A1 in Northumberland: Morpeth to Ellingham

7.6D Statement of Common Ground with Historic England

**Statement of Common Ground with
Historic England**

Version	Date	Status of Version
Rev 5	May 2021	Deadline 8

Potential waterlogged archaeological remains within the scheduled burial mound

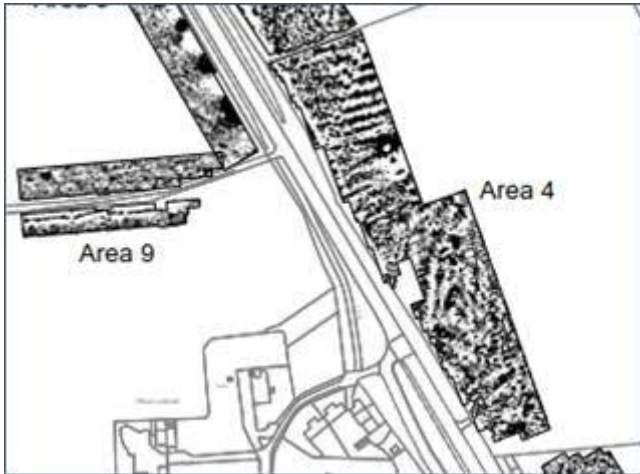
Section 5.4.48 of the draft EIA highlights the potential for the development to change the groundwater levels within the area, allowing decay processes to set in within buried archaeological remains, including deposits associated with the scheduled bowl barrow. We welcome the acknowledgment of this potential issue, as it highlights the fact that even if development doesn't encroach on the scheduled site itself it could still have a harmful impact on its significance (up to and including substantial harm).

As far as we can see the EIA doesn't go on to suggest how this potential should be dealt with. We would suggest, as above, that in advance of the DCO application there is a need to:

The removal of the detention basin from this field and the exclusion of the entire field from the application boundary has removed this as a potential impact on this asset. As part of the assessment on all aspects of the

historic environment, I will be cross referencing the assessment work being undertaken by the hydrology team in order to determine the impacts.

West Linkhall Scheduled Monument

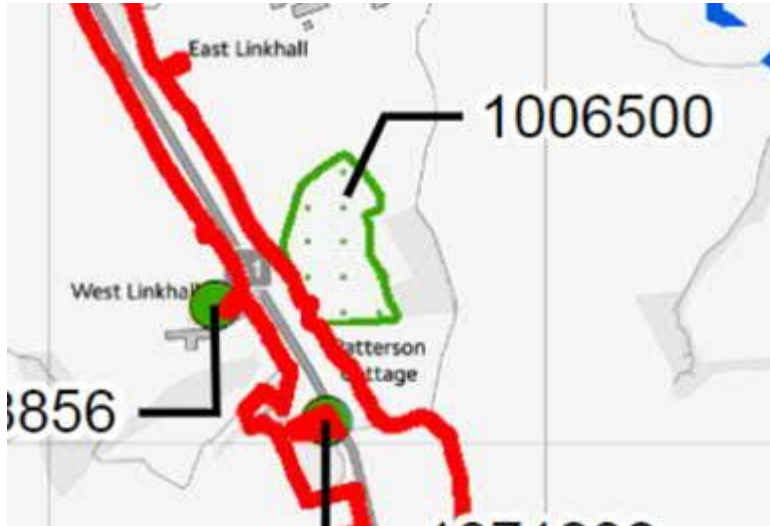
The second query was the impact on the setting of the scheduled monument Camp at West Linkhall . Below is the scheme design in this location. The existing road will be widened to the east, towards the monument. There will be haul running along the east side of it. The current highway here is elevated and runs on an embankment, and the scheme design includes widening the embankment. The embankment will then drop towards the scheduled monument, but will fall short of its boundary. I have attached a photograph taken on the site (Image: Camp at Linkhall). This is taken from the north end of the site looking south. Please let me know if you need any more information.

West Linkhall Scheduled Monument

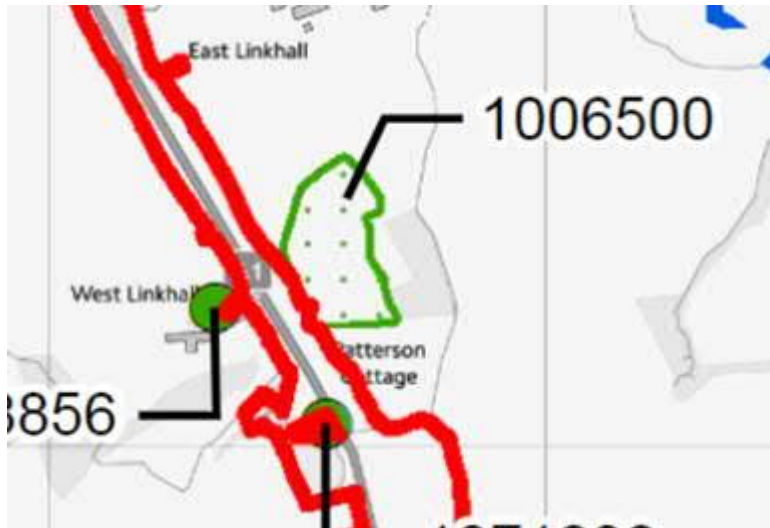
The second query was the impact on the setting of the scheduled monument Camp at West Linkhall . Below is the scheme design in this location. The existing road will be widened to the east, towards the monument. There will be haul running along the east side of it. The current highway here is elevated and runs on an embankment, and the scheme design includes widening the embankment. The embankment will then drop towards the scheduled monument, but will fall short of its boundary. I have attached a photograph taken on the site (Image: Camp at Linkhall). This is taken from the north end of the site looking south. Please let me know if you need any more information.
